Sikorsky Aircraft Corporation

SPECIAL SERVICE INSTRUCTIONS

SSI No. 92-121

Subject: ROTOR DRIVES – Main Gear Box (MGB) Oil Pressure, Temperature, and Pump Warning – Installation of Auxiliary Circuit Breaker Panel and M XMSN PRESS SWITCH Circuit Breaker Modification Kits

WIRE ROUTING FOR M/K LH CABIN AUXILIARY POWER UNIT (92070-55096-013)
BEGINNING OF ROUTE
FIGURE 5 (SHEET 1 OF 2)

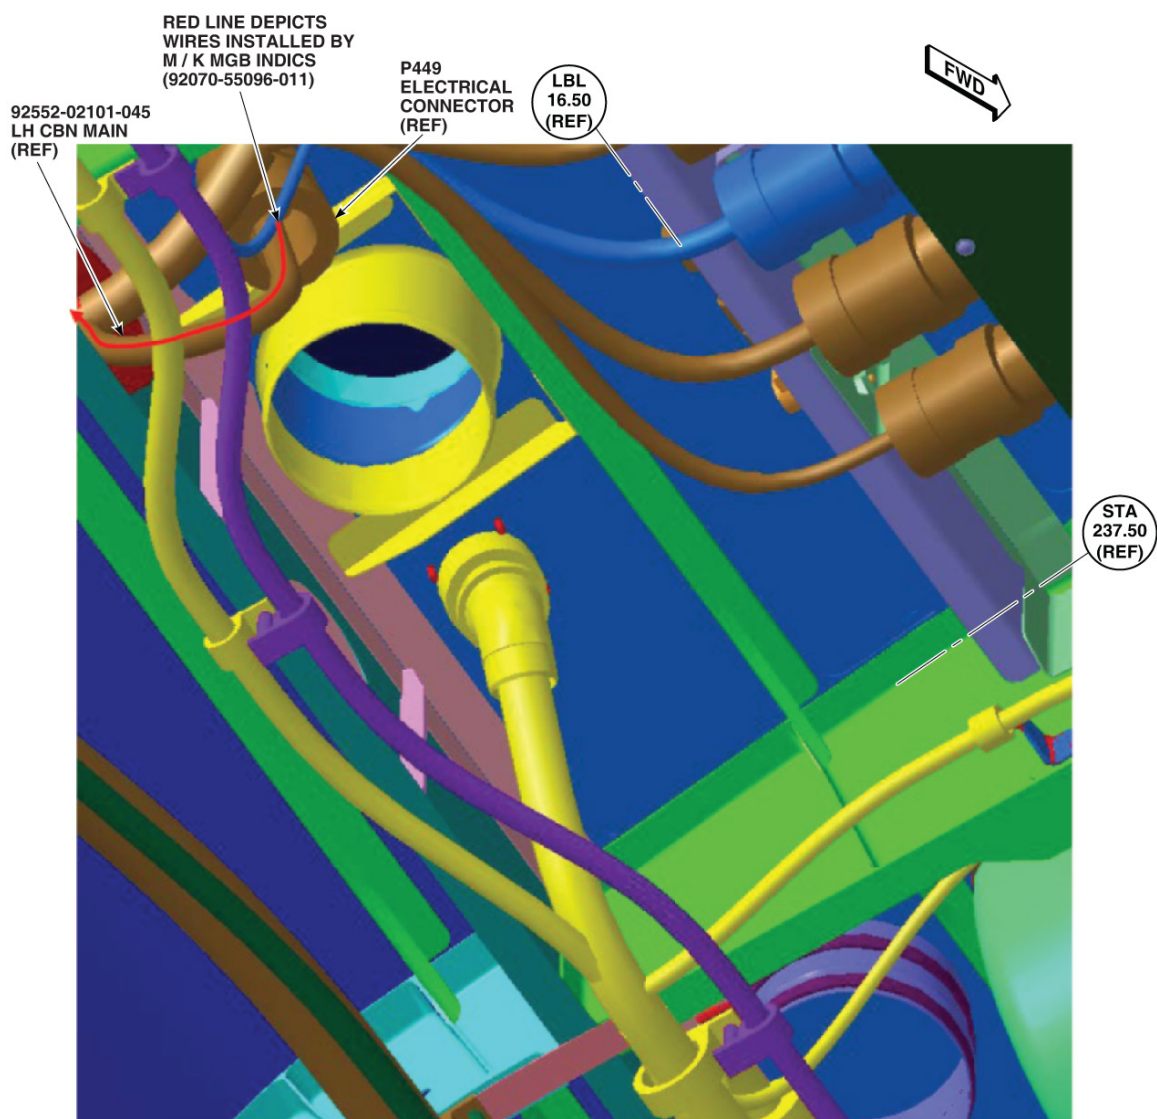
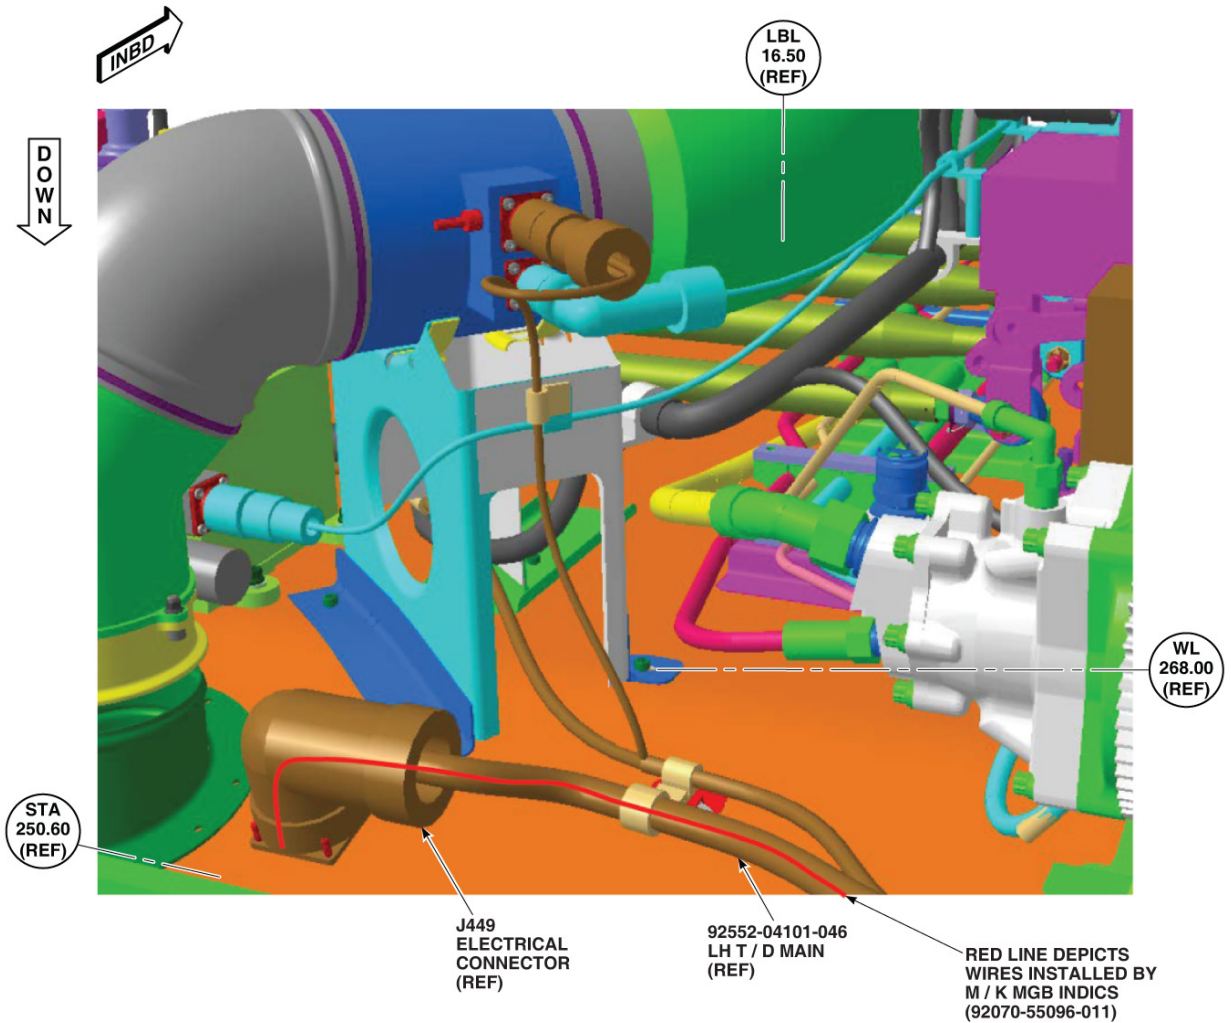
- (1) Install W/G LH cabin APU (92552-55096-042).
 - (2) Route new wire (W4422C24) along existing wiring harness LH cabin main (92552-02101-045), from electrical connector (P111) near STA 237.50, WL 251.00, LBL 35.00, to electrical connector (P449) near STA 237.50, WL 265.00, LBL 16.50 (Figure 5, Sheets 1 and 2).

WIRE ROUTING FOR M/K LH TOP DECK FLD (92070-55096-016)
BEGINNING OF ROUTE
FIGURE 6 (SHEET 1 OF 2)

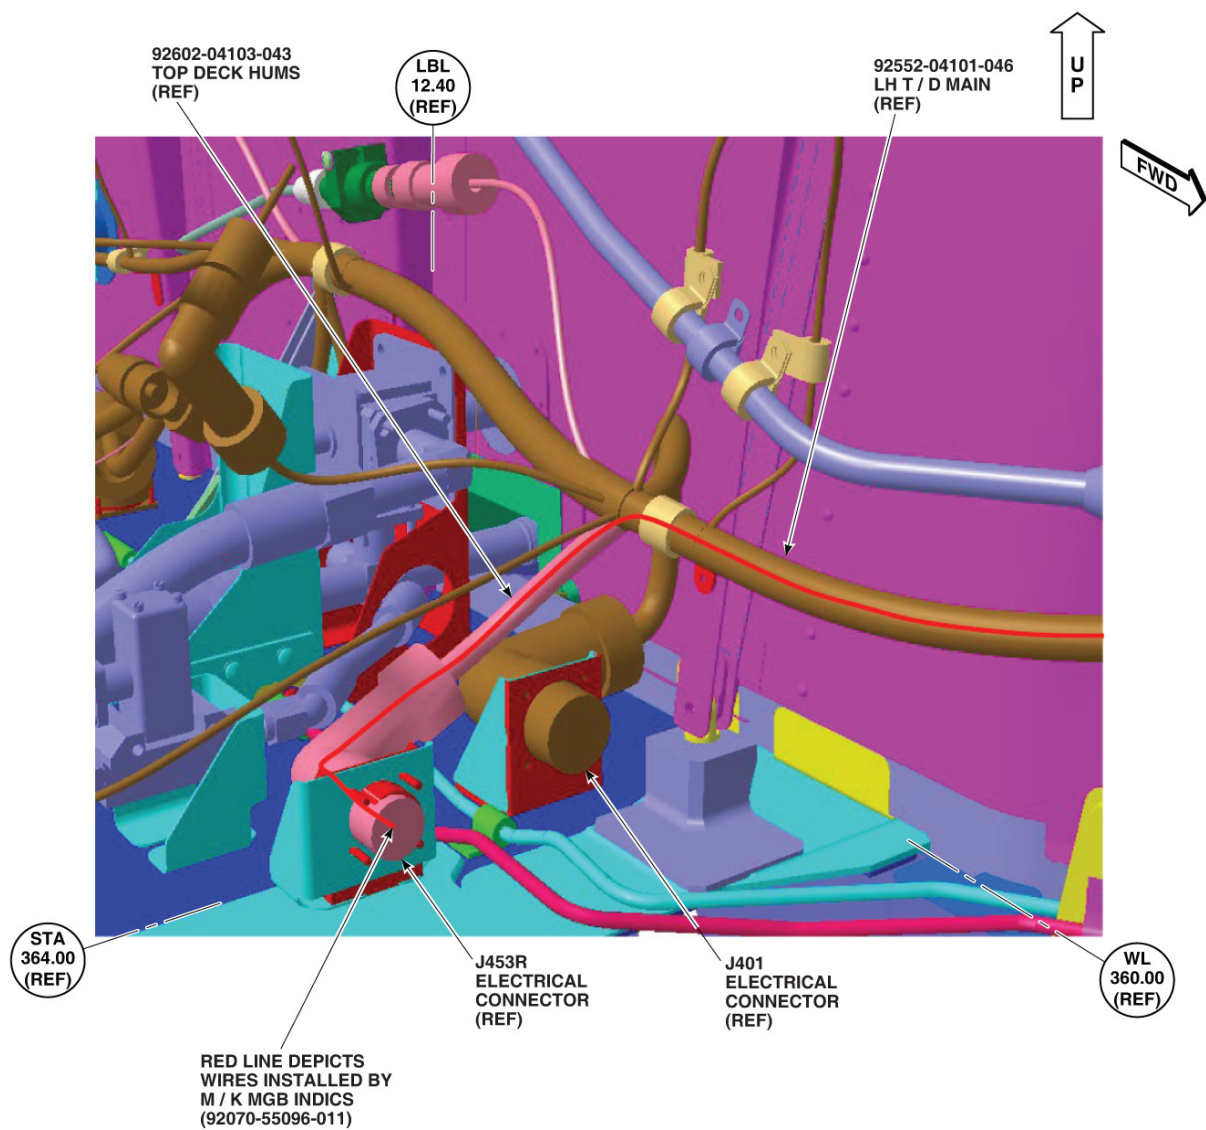
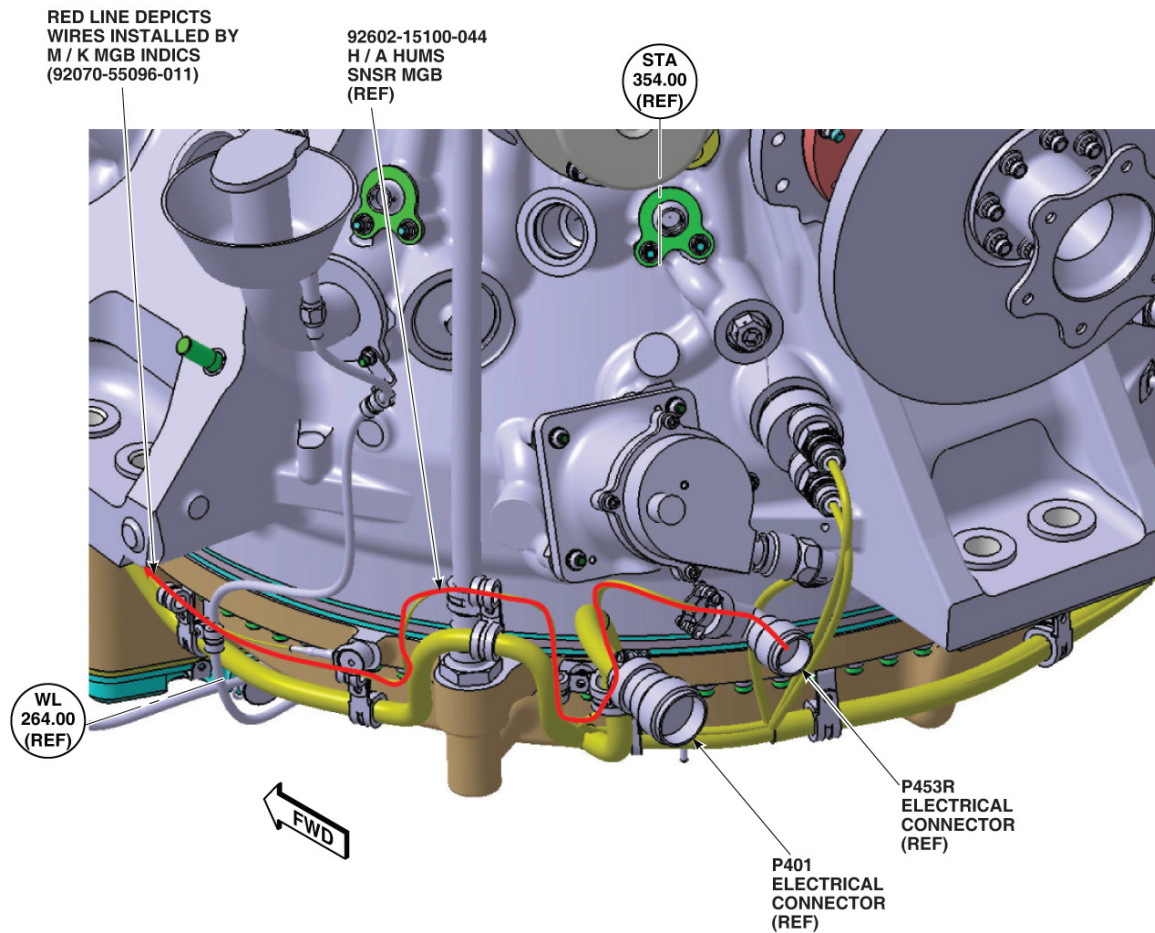
- (1) Install W/G LH top deck (92552-55096-043).
- (2) Route new wire (W4422B24) along existing wiring harness LH T/D main (92552-04101-046), from electrical connector (J449) near STA 250.60, WL 268.00, LBL 16.50, then along existing wiring harness top deck hums (92602-04103-043) to electrical connector (J453R), STA 364.00, WL 360.00, LBL 12.40. Cover wire with HR ½ sleeving (625300413 or equivalent) and wire braid (AA59569R36T0203 or equivalent). Terminate braid at braid terminator at rear of electrical connector J449. (Refer to Figure 6, Sheets 1 and 2).

WIRE ROUTING FOR M/K MGB XMSN (92070-55096-017)
BEGINNING OF ROUTE
FIGURE 7 (SHEET 1 OF 3)

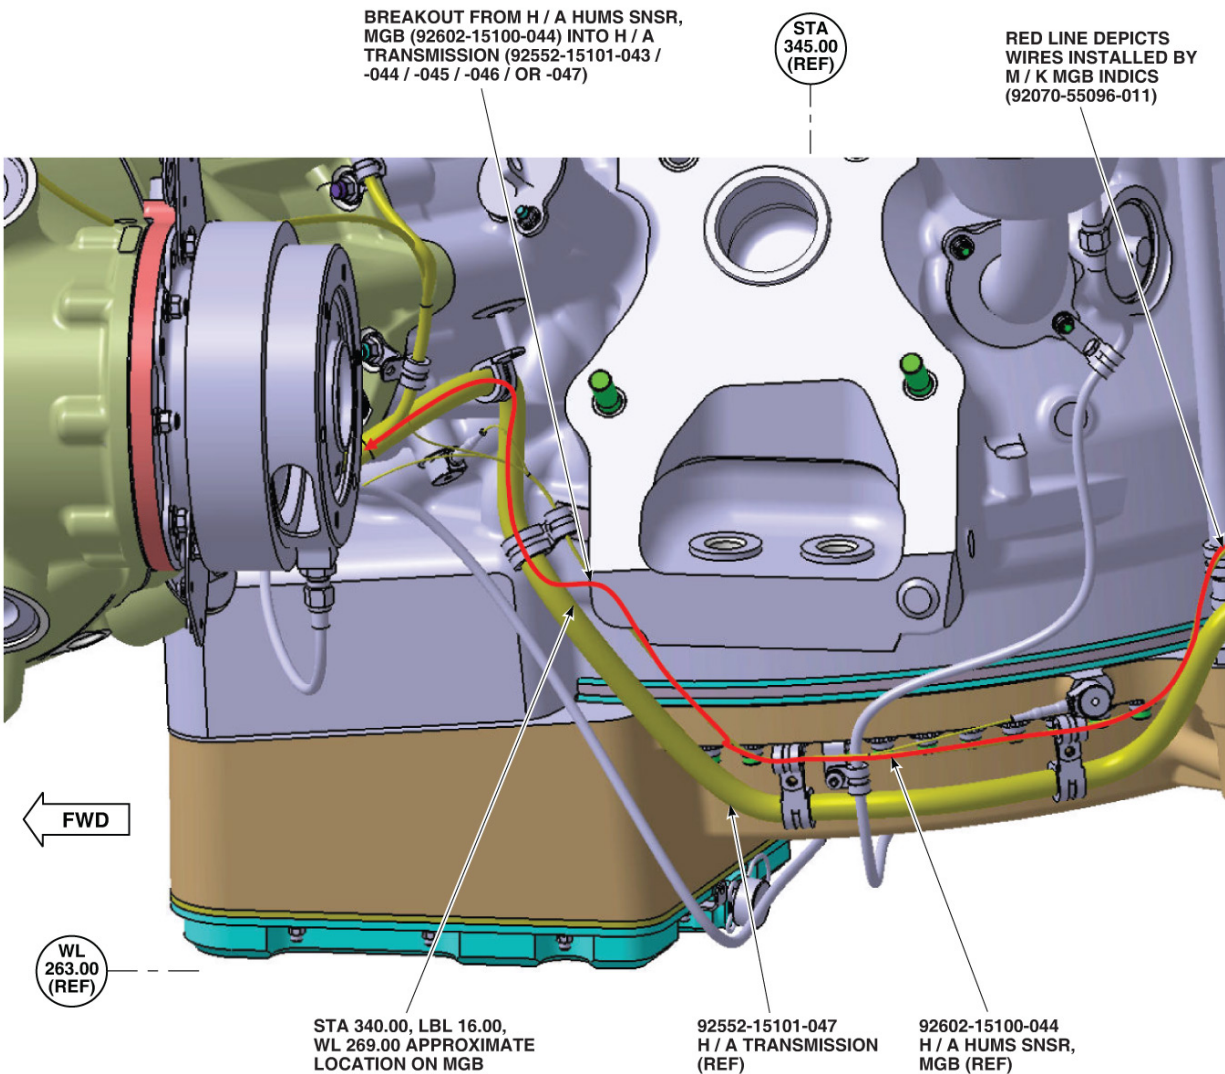
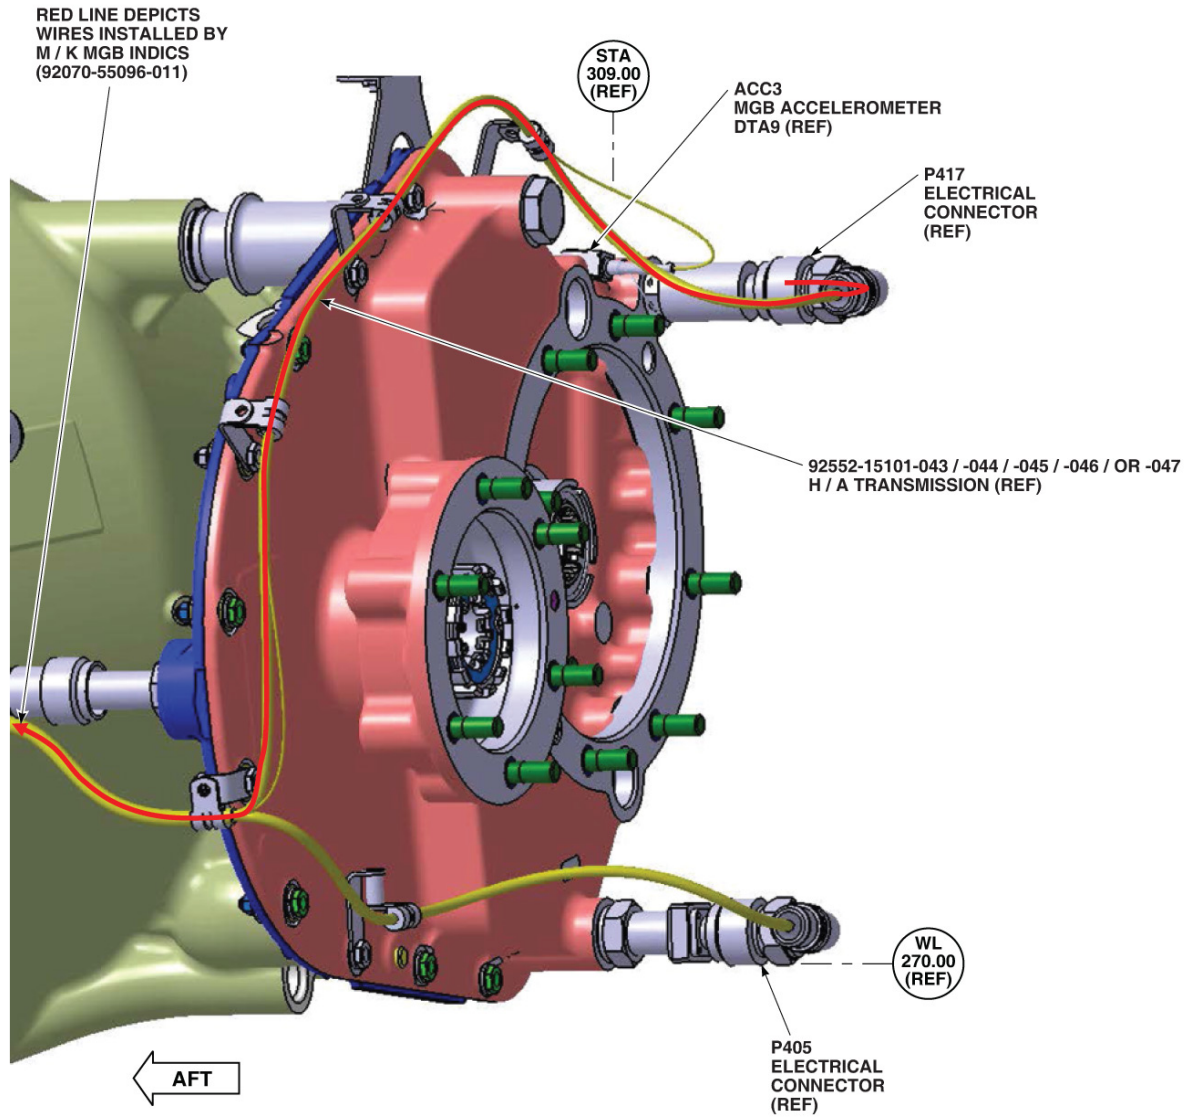
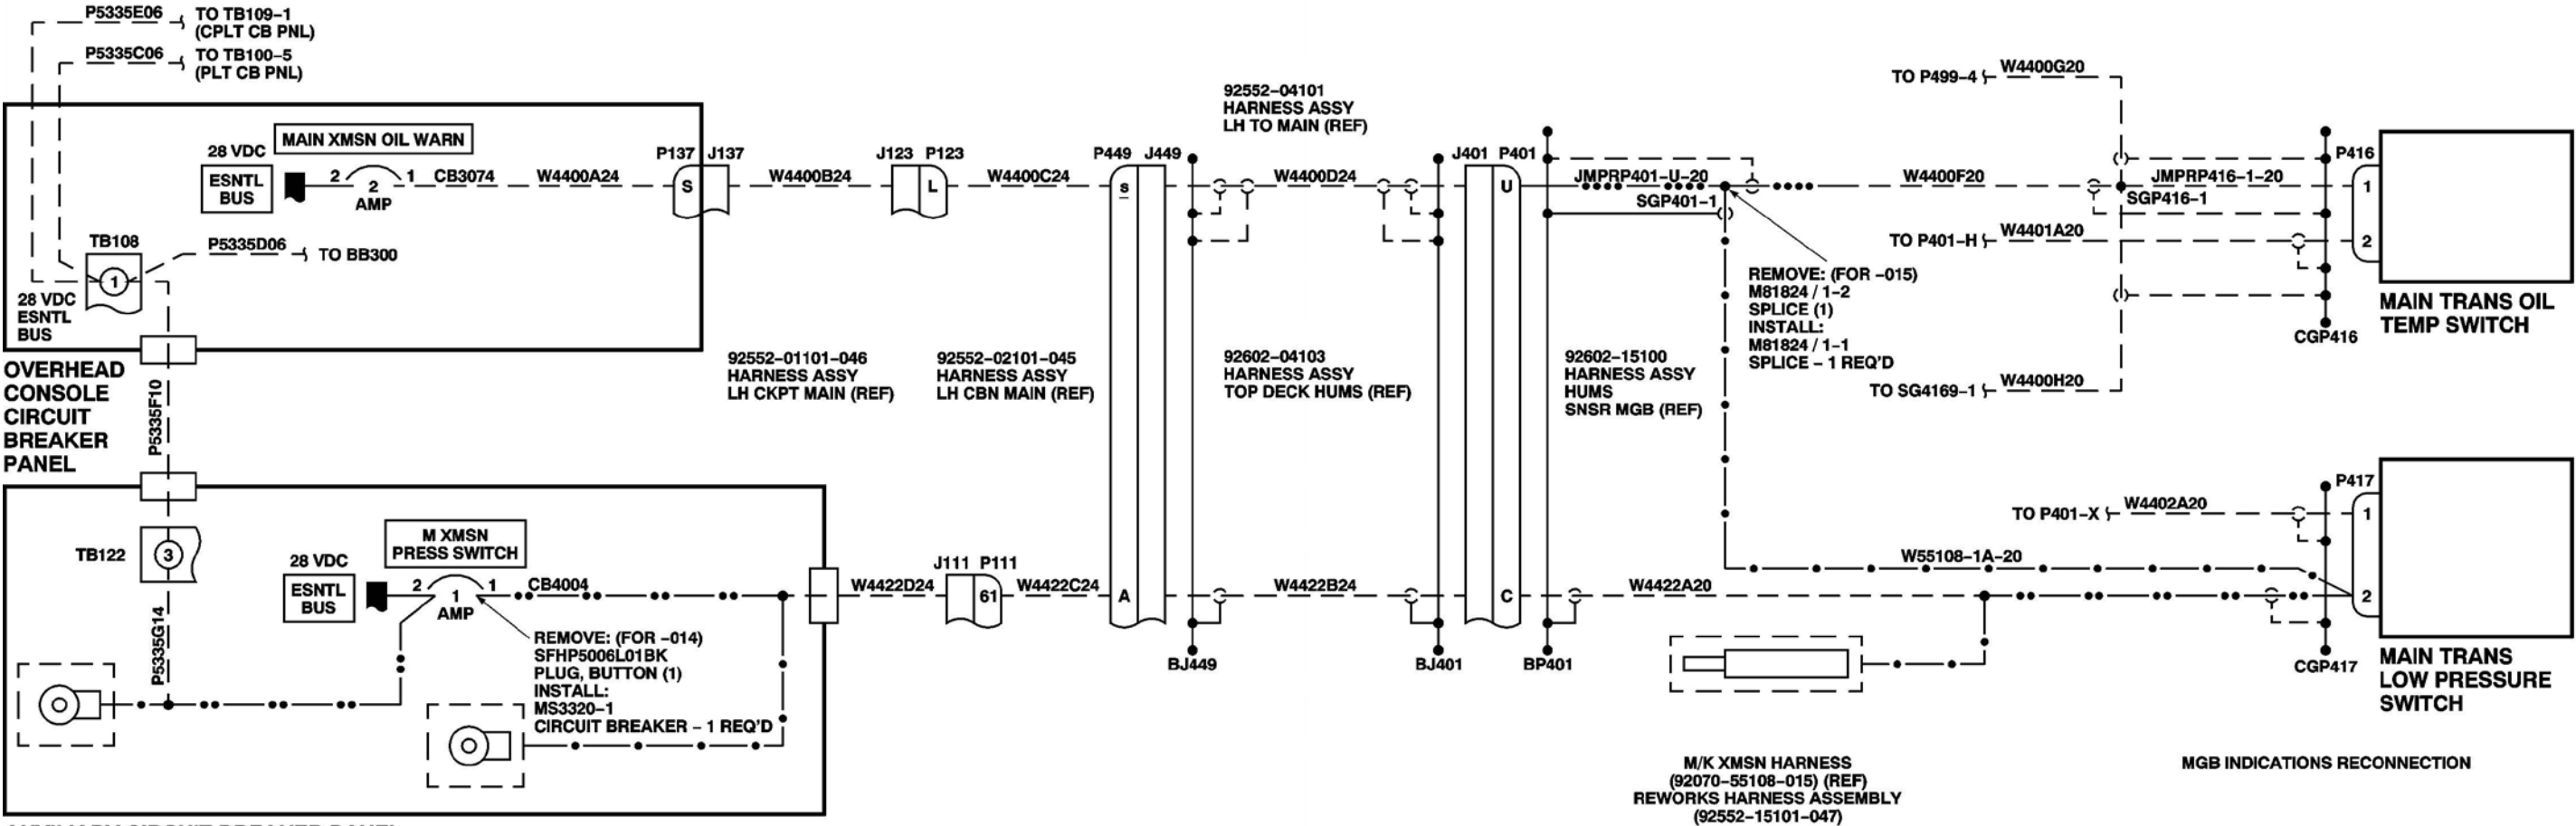
- (1) Install W/G XMSN FLD (92552-55096-045).
- (2) Cover wire (W4422A20) with shrink tubing (SS7072E0250ZXXX) (Figure 3).
- (3) Route new wire (W4422A20) along existing wiring harness HUMS sensor, MGB (92602-15100-044), from electrical connector (P453R) near STA 354.00, WL 264.00, LBL 10.80, then breakout from HUMs sensor, MGB (92602-15100-044) to route along existing wiring harness H/A transmission (92552-15101-043/-044/-045/-046 or -047) near STA 340.00, WL 269.00, LBL 16.00. (Refer to Figure 7, Sheets 1 and 2).

- (4) Route new wire (W4422A20) along existing wiring harness H/A transmission (92552-15101-043/-044/-045/-046 or -047) to electrical connector (P417) near STA 309.00, WL 270.00, LBL 22.00 (Sheet 3).

- (21) Tie new wire (W4422A20) to existing wiring harnesses HUMS sensor, MGB (92602-15100-044) and H/A transmission (92552-15101-043/-044/-045/-046 or -047) using lacing tape (SS7057-2). (Refer to Figure 7, Sheets 1-3, and Maintenance Manual, SA S92A-AMM-000, Task 20-20-02-910-002).
